PREESE HALL SHALE GAS FRACTURING

REVIEW & RECOMMENDATIONS FOR INDUCED SEISMIC MITIGATION

We have been asked by DECC to review these reports, and the further studies and information provided by Cuadrilla; and to make appropriate recommendations for the mitigation of seismic risks in the conduct of future hydraulic fracture operations for shale gas.

Figure 1: Graphs showing a) variations of analysed parameters with depth and b) overlay prefrac surface treating pressure plots.

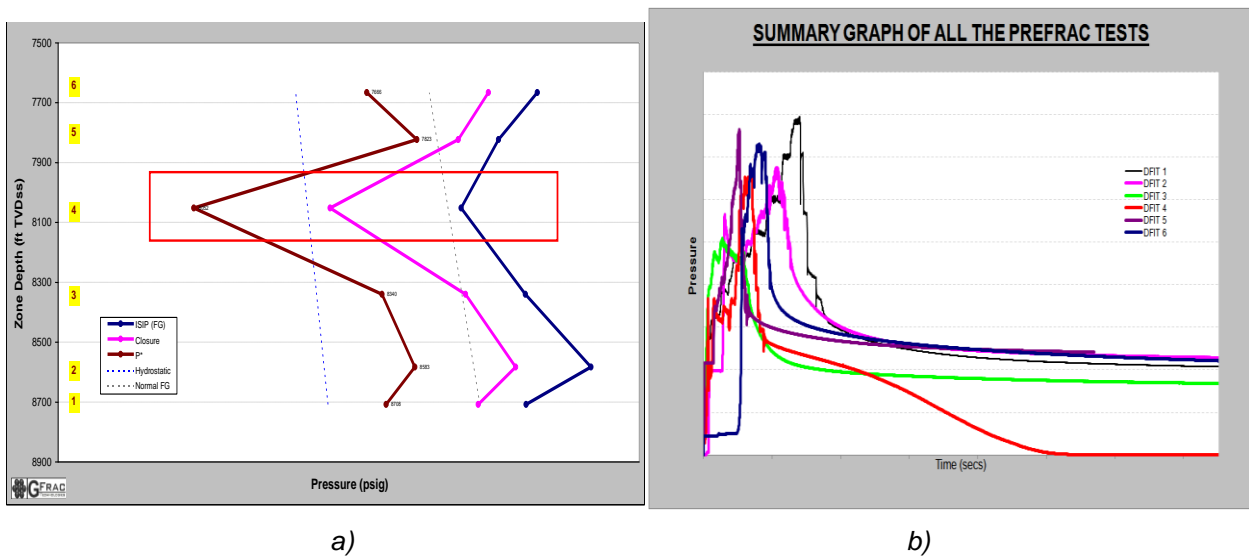
The plots of the treatment variations with depth are shown in Figures 1a) and 1b) and the only obviously exceptional zone is zone 4, as highlighted in Figure 1a. Zone 4 prefrac injection test analysis indicates that the fracture grew into a much lower stress zone and exhibited "fracture height recession" type leak-off characteristics, here probably representing the created fracture being forced into high-stress impermeable layers, which are forced to close first. We interpret this as possibly being at, or very near, to the fault, which is then proposed as a possible explanation of the subsequent immediate seismic events, while injecting into zones 4 and 5.

Figure 2: Graph showing fracture gradient vs closure gradient relationship.

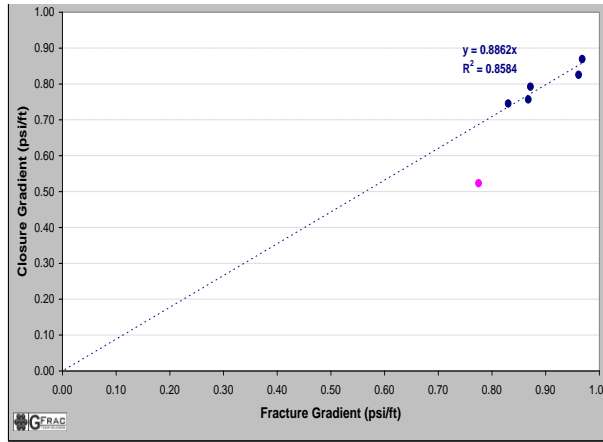
Overall, the results indicate distinct and separate behaviours for each zone, interpreted as being representative of good containment of the created fracture growth in each zone. However, we consider that there is little additional useful information that can be concluded about the resultant fracture growth using only the surface job data, given the lack of complementary diagnostics.

Figure 3: Woodford shale measured fracture heights compared to aquifer depths (copyright SPE)

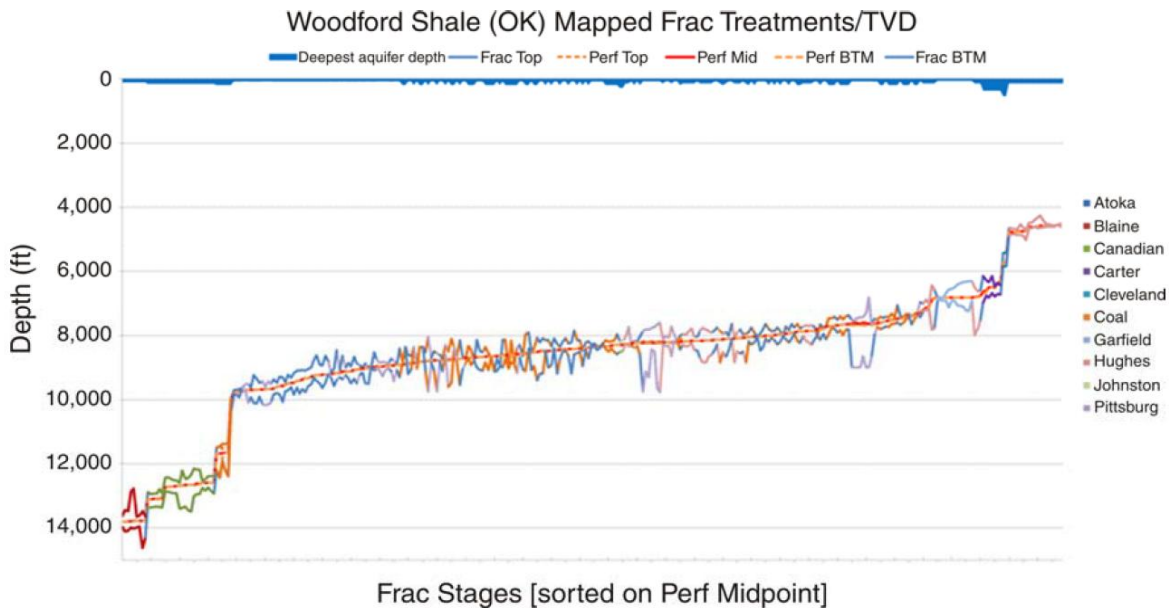
One of the major concerns with shale gas developments is answering the question of how the created hydraulic fracture grew, particularly in relation to shallower aquifers. A summary of US microseismic and tiltmeter data in shales has recently been published (Fisher and Warpinski, 2011) based on treatments carried out in the Barnett, Woodford, Marcellus and Eagle Ford shales. This work is of particular interest as it summarises how the fractures grew with respect to the overlying aquifers. Overall, the data indicate that in general for deeper shales (here classified as >4000ft TVD_{SS}), the created hydraulic fractures remain well confined to the target interval, even in the presence of faults, (see Figure 3 and also Figures 4-6).

Overall, the US data indicates that faults do not provide a mechanism whereby created fractures are able to propagate significantly upwards, towards the surface. The presence of faults is generally indicated by large upward and downward growth spikes, but overall vertical growth is still limited to several hundreds of feet. The Woodford shale is probably the best analogue for the Bowland shale, as it also has a very complex geology which also includes faulting and highly dipping or overturned bedding planes. However, interpretation of the

Woodford, in common with the Barnett, shows that created hydraulic fracture heights are well contained and separated from the local aquifers by at least several thousand feet. (In US regulatory practice, the focus would be on protection of aquifers used, or potentially usable, for drinking water supplies. It is our understanding that in the UK, the Environment Agency would aim to secure appropriate protection of all groundwater.)
